**West Point City  
Planning Commission Agenda  
February 12, 2026  
WEST POINT CITY HALL  
3200 W 300 N WEST POINT, UT**

**RE: Sky Meadows - Preliminary Plan Review**

6. Storm Drainage

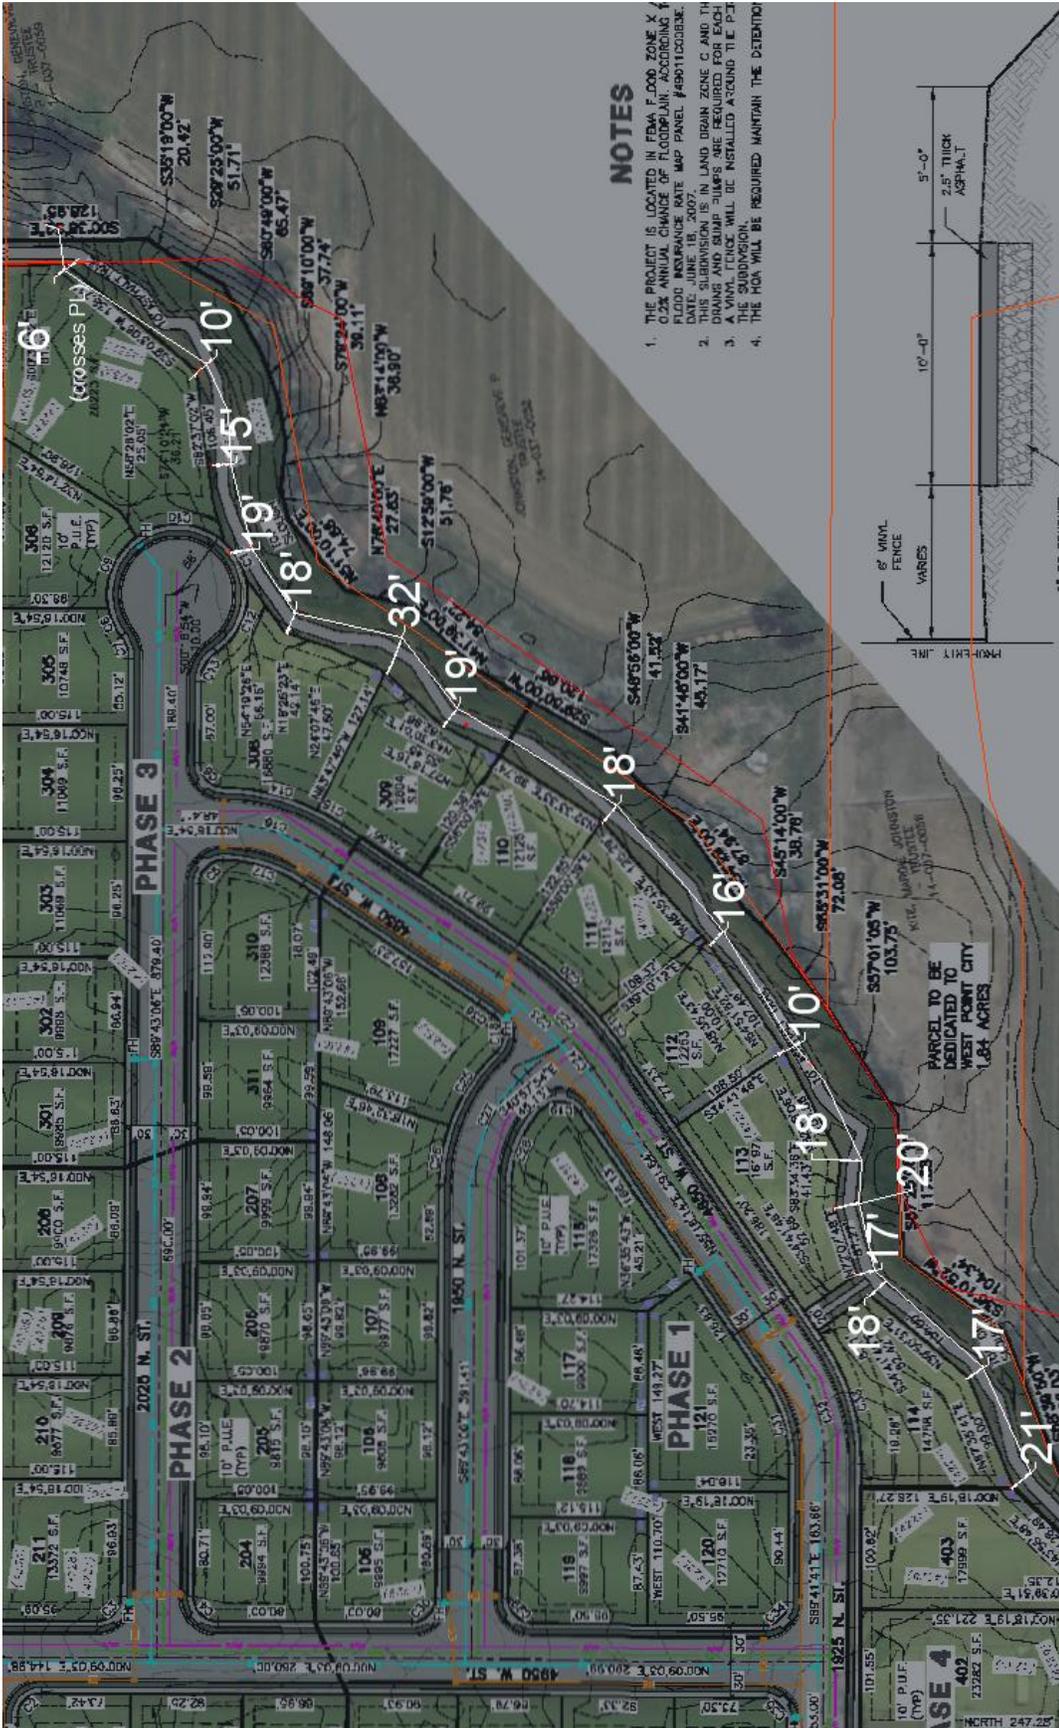
- a. ~~Permit from Davis County will be required to discharge into the Howard Slough. This will be required at final plan review.~~
- b. ~~Approval from UDOT to install storm drain pipe on 5000 W. This will be required at final plan review.~~
- c. ~~The adjacent subdivision will connect to the storm drain in this subdivision. The pipe must be upsized to accommodate this. An agreement between the two developers may be required.~~
- d. ~~Show the existing pipe on 5000 W connecting to the new proposed pipe.~~
- e. ~~An HOA will be required to maintain the detention pond.~~

Preliminary Plan

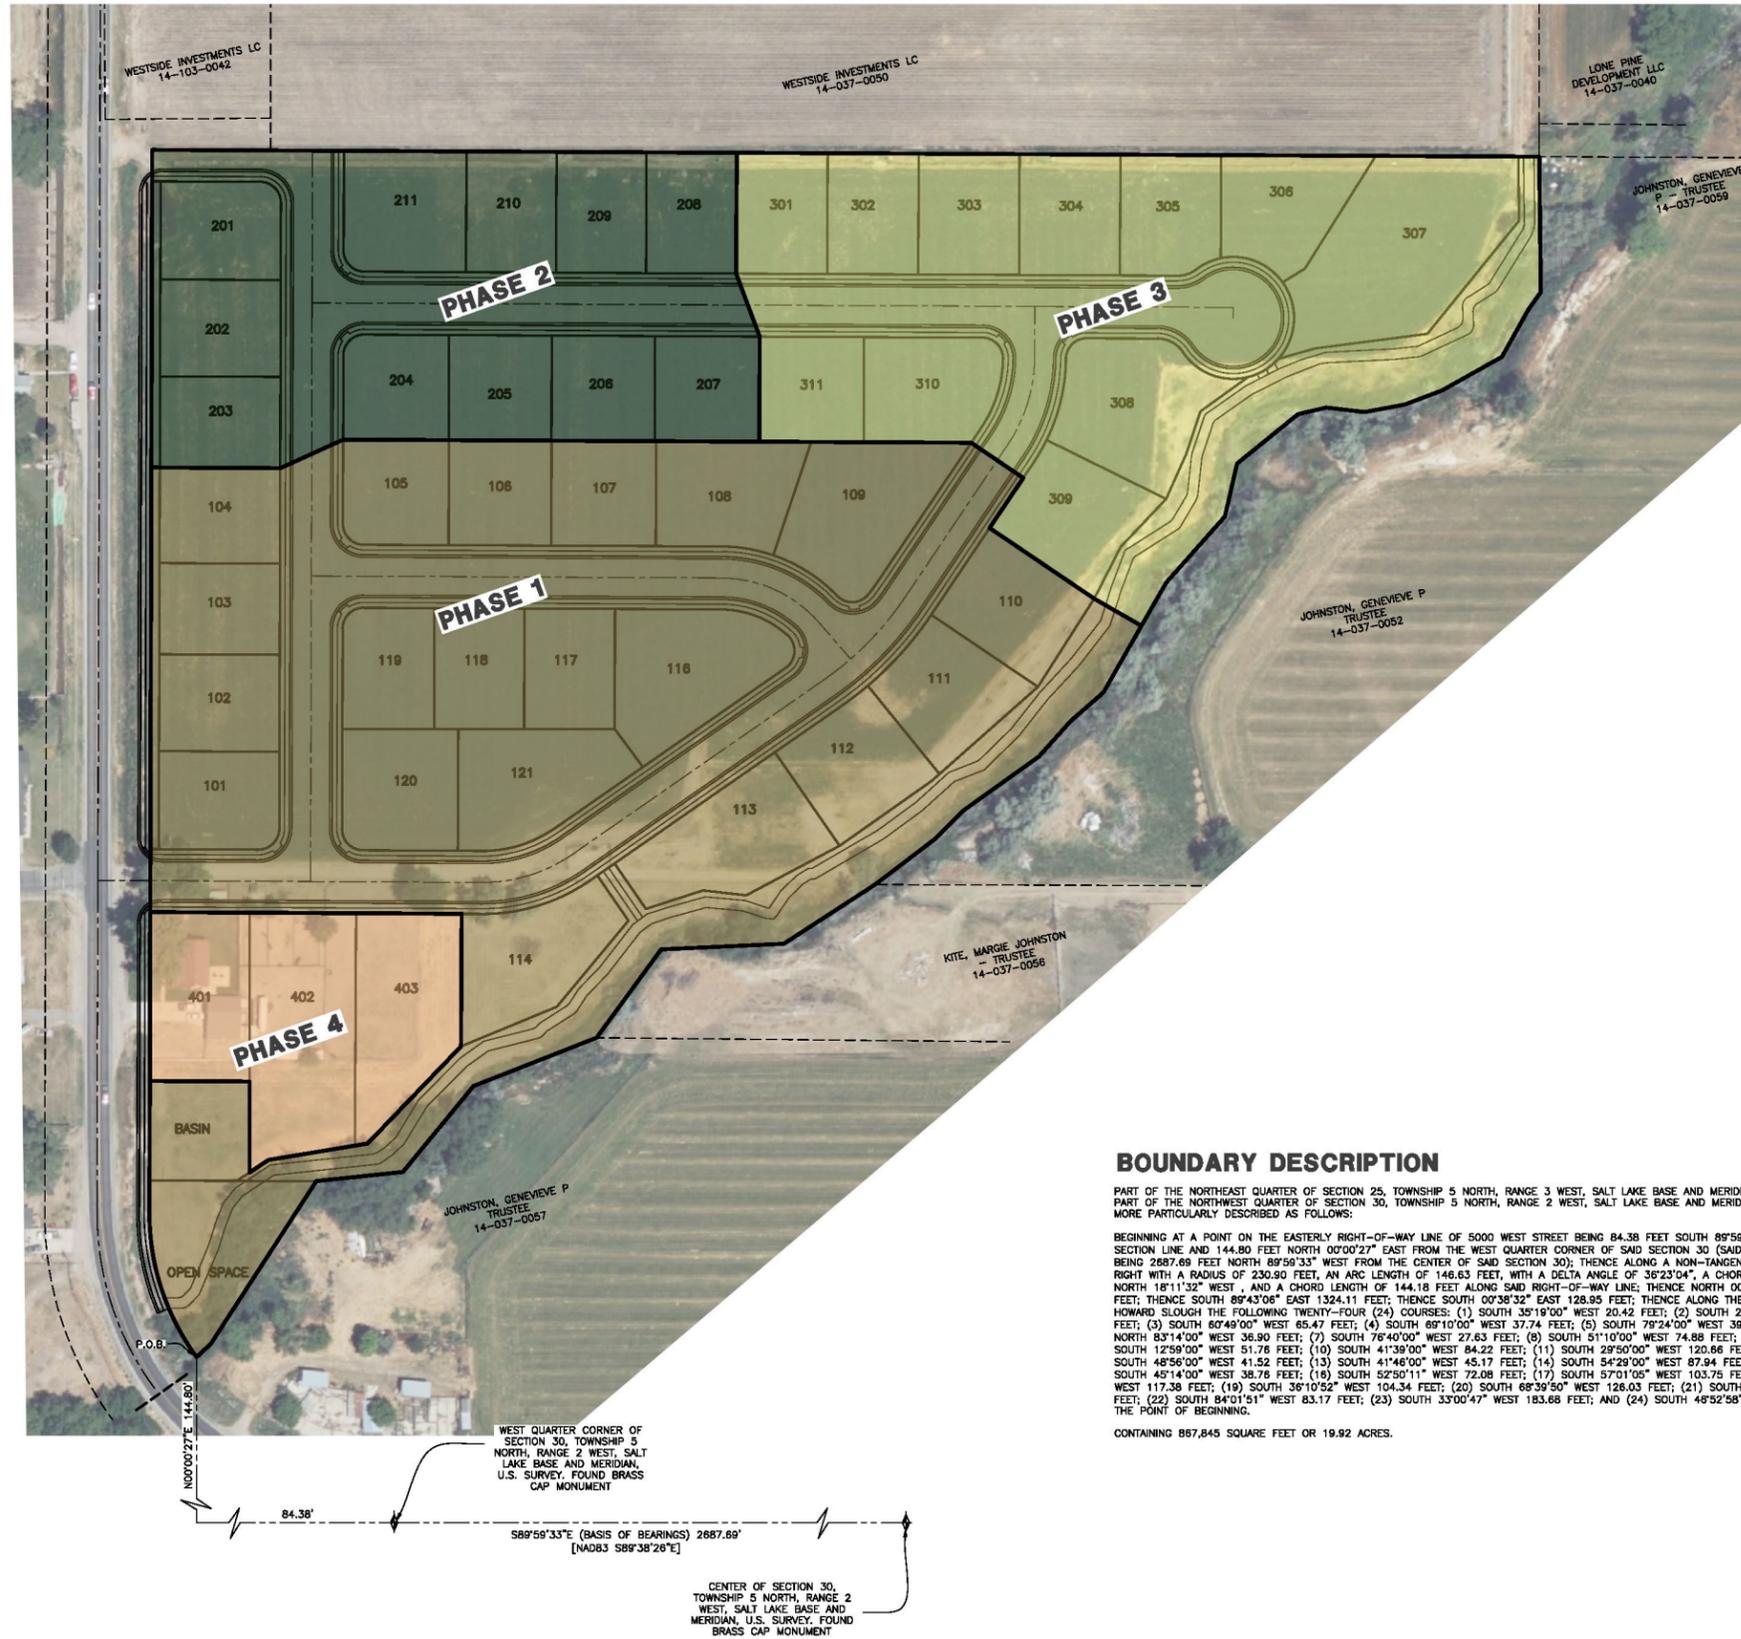
- a. ~~A fence will be required around the perimeter of the subdivision per the PRUD code requirements. There is no fence shown on the plan.~~
- b. **Show fencing to protect the sidewalk and trail at the curve on 5000 W.**
- c. ~~In addition to the road, there is a large storm drain culvert at this location. Safety issues should be considered.~~
- d. **The area being dedicated for the trail must be verified to see if there is enough flat area for the trail. (see attached sheet)**
